WE ARE THE
Scentmakers®

Locker Room Site locations

Employee Voice – 30th August

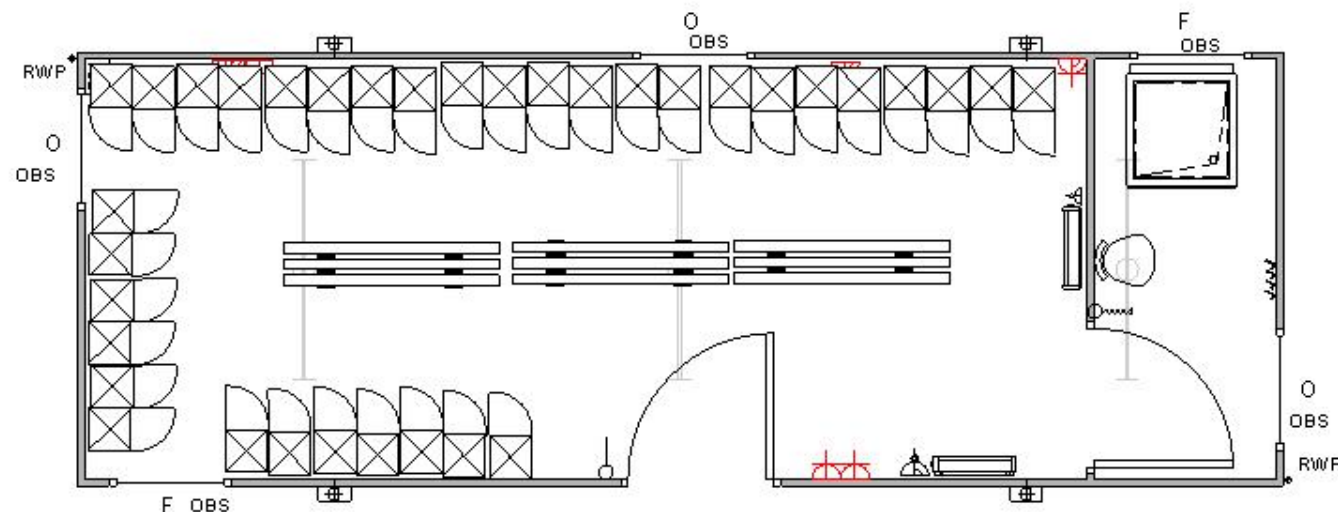
The men's room is an 8m by 3m building.
There are 35 half lockers in there to accommodate for the 70 people
To confirm if this is enough changing space for everyone? I can fit all this in a bigger building to fit more benches etc in there but I'm not sure how many people would be in there at any one time.

- Portakabin will provide the lockers
- The only feedback received by Jayne regarding the locker rooms was that one shower wasn't sufficient and could they have different benches.
- Need to ensure that this meets the needs of the Lab areas – Sample Despatch, creative lab
- No location considered is central to Herbals / Analytical buildings, would need to consider where we could site something for these areas?
- Need small banks of mobile phone lockers outside key entry points
- Need a visitor area where they can store phones and acquire the correct PPE before entering site – creates a more professional, health and safety aware site.
- Longer term need to consider laundering of workwear

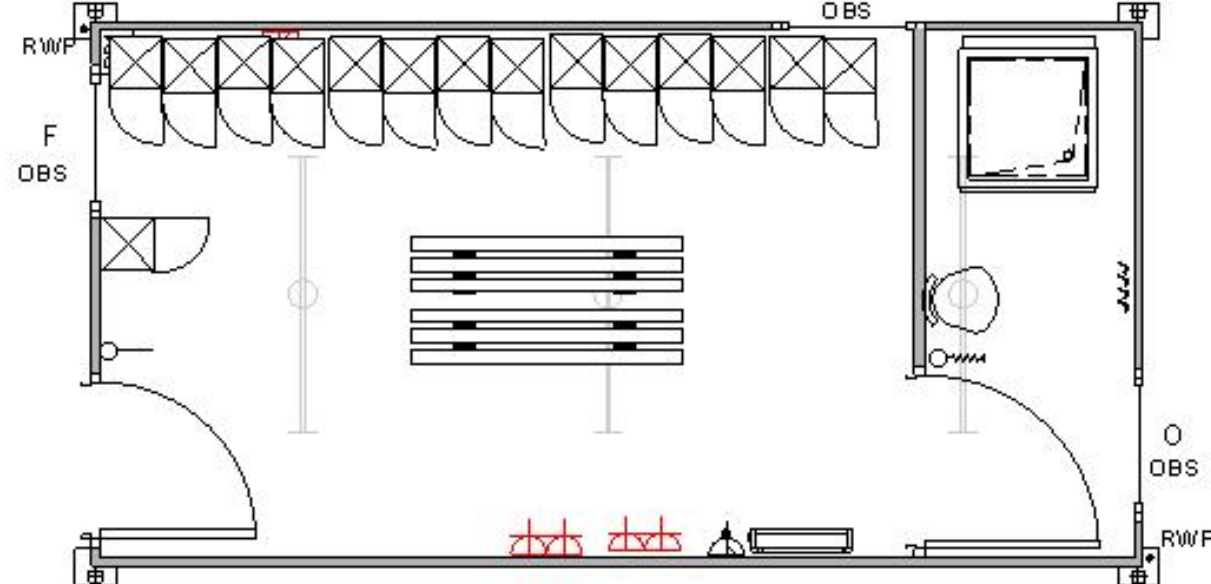
The Ladies room is a 6m by 3m building
15nr full size lockers and a couple benches with hooks and the shower.
